**SUZUKI****CAMPAIGN
BULLETIN****Bulletin Number: ATVC05-01****Date: 08/28/07 Revised****Page: 1 of 6****Subject: Customer Satisfaction Campaign -
ECM Replacement****Affected Models: 2005 LT-A700XK5 King Quad****Read & Initial****Manager** _____**Parts** _____**Service** _____**CAMPAIGN BULLETIN CONTENTS**

CAMPAIGN NOTICE

REPAIR PROCEDURE

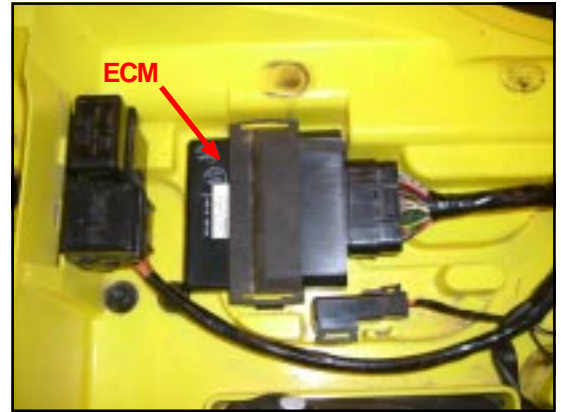
- 1) Remove the seat and inspect the ECM. If the ECM has a white painted dot or the new updated part number (32920-31G01, 32920-31G02, 32920-31G03 or higher) on the Nippon Denso label no further action is required. The reprogrammed ECM is already installed. If either the white painted dot or an updated part number is not present, continue to step 2.

- 2) Remove the ECM from the mount tabs on the rear fender and disconnect the wire harness coupler. Remove the suspension rubber from the ECM.
- 3) Install the suspension rubber to the new ECM, connect the wire harness coupler and insert the ECM to the mount tabs on the rear fender. Install the seat.
- 4) Owner's Manual inserts describe the revised functioning of the reverse override mode.
